**HMC ARCHITECTS
3546 Concourses Street
Ontario, California 91764**

Arvin High School ESSER III Phase 1 Roofing

Kern High School District

File No: 15-H3 A#03-122508

BIM 360://3566002000 Arvin HS ESSER III 3566002000-A KHSD Arvin HS Roof Replacement.rvt
6/21/2024 4:02:35 PM

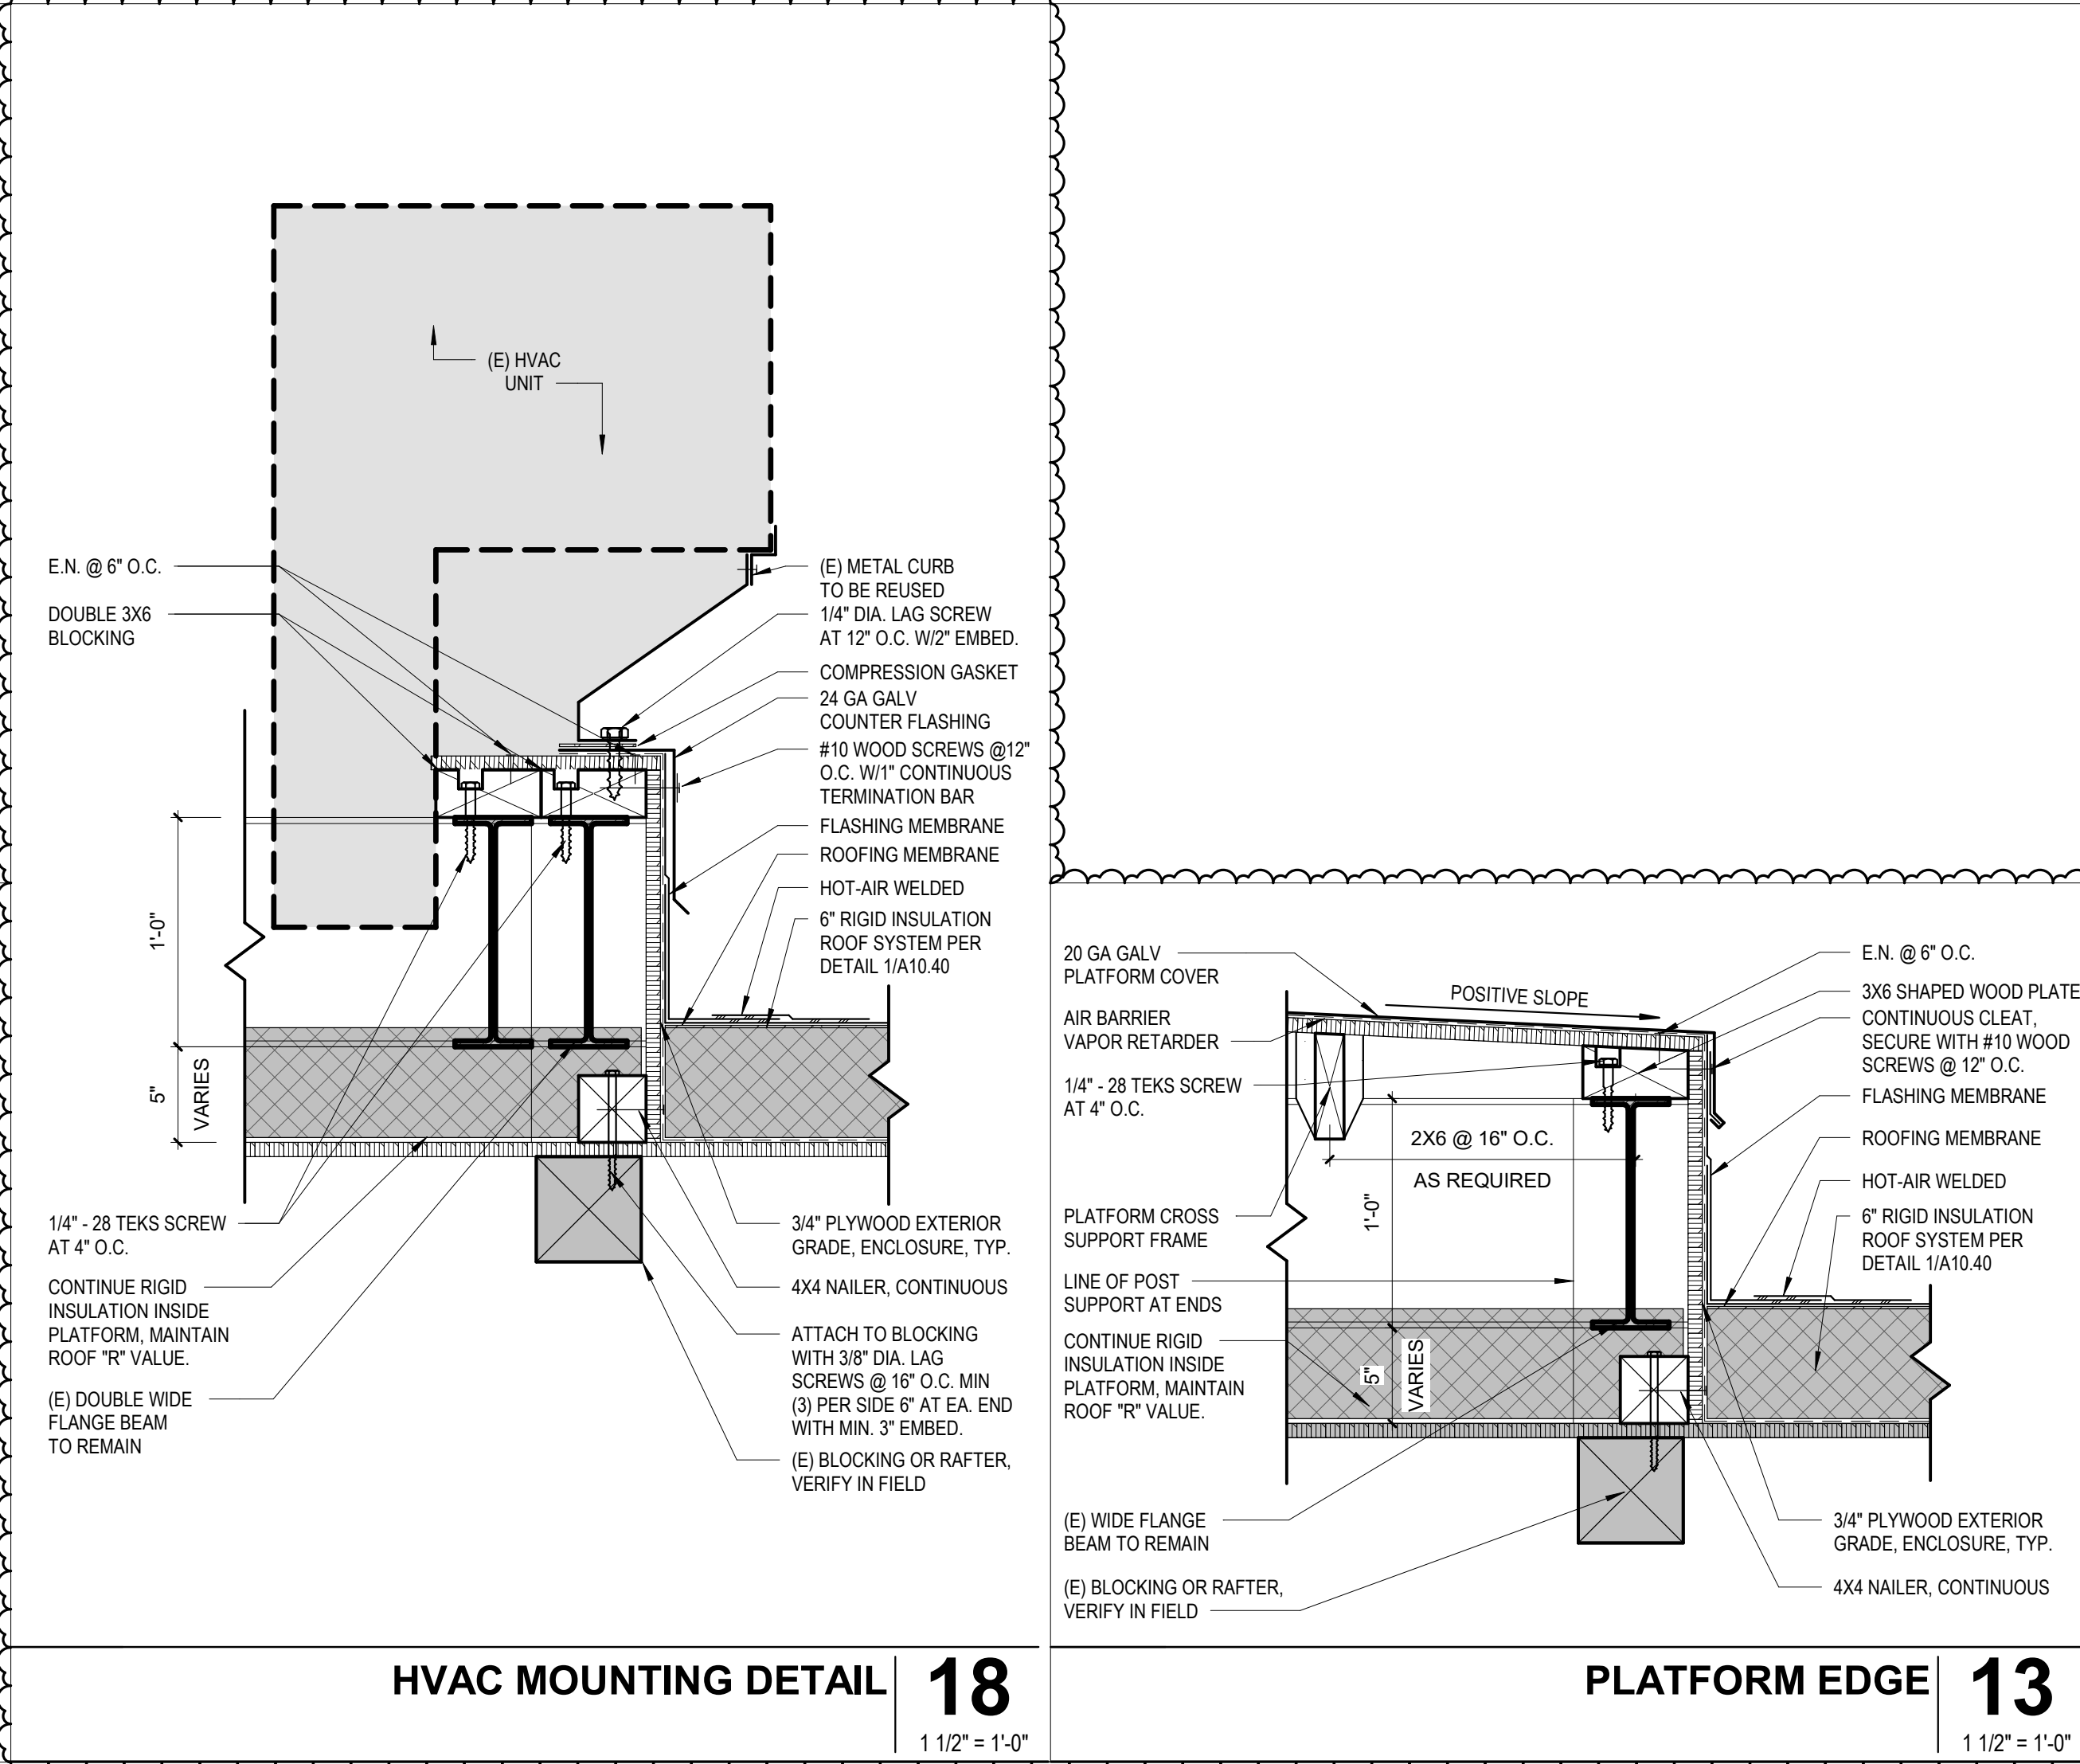
- A. **ADD** Details 8/A10.42 – Platform Edge and 12/10.42 – HVAC Mounting Detail to the Drawing Sheet as shown and clouded per Delta 3.
